Applicant: Cong Thanh DINH  
Application Serial No.: 10/764,105  
Filing Date: January 23, 2004  
Docket No.: 577-614  
Page 8

Title: ELECTRICAL TERMINATION COMPONENT BRACKET

Annotated Sheet Showing Changes

FIG. 3

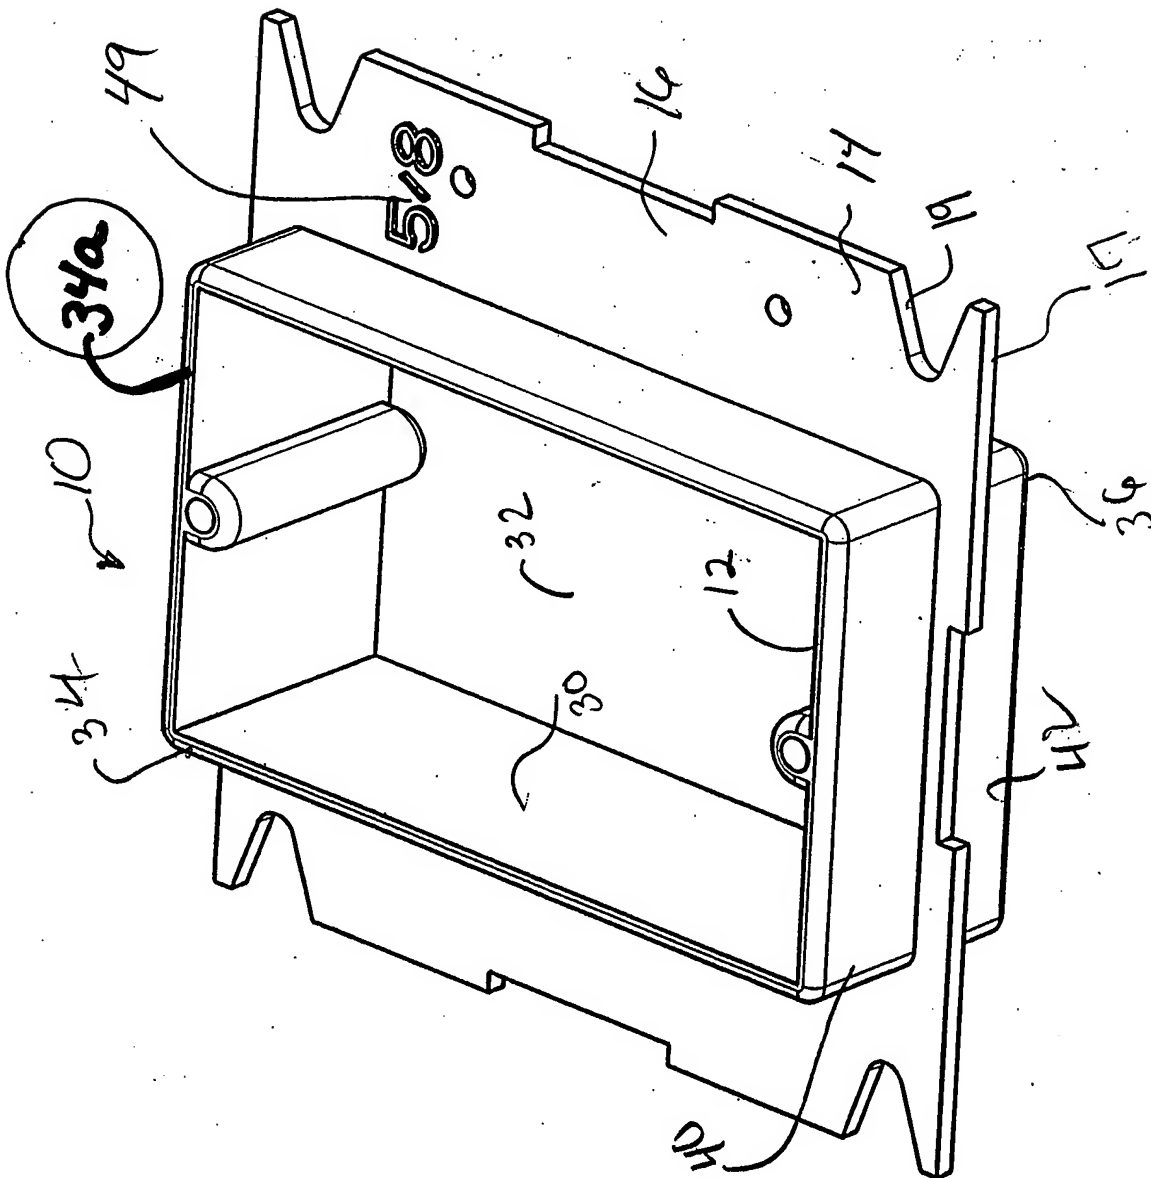
The attached sheet of drawings includes changes to Figure 3 and Figure 4. These sheets, which includes Figures 3 and 4 replaces the original sheets including Figures 3 and 4. In Figure 3, previously omitted element 34a has been added. In Figure 4, previously omitted element 36a has been added.

Element 34a added
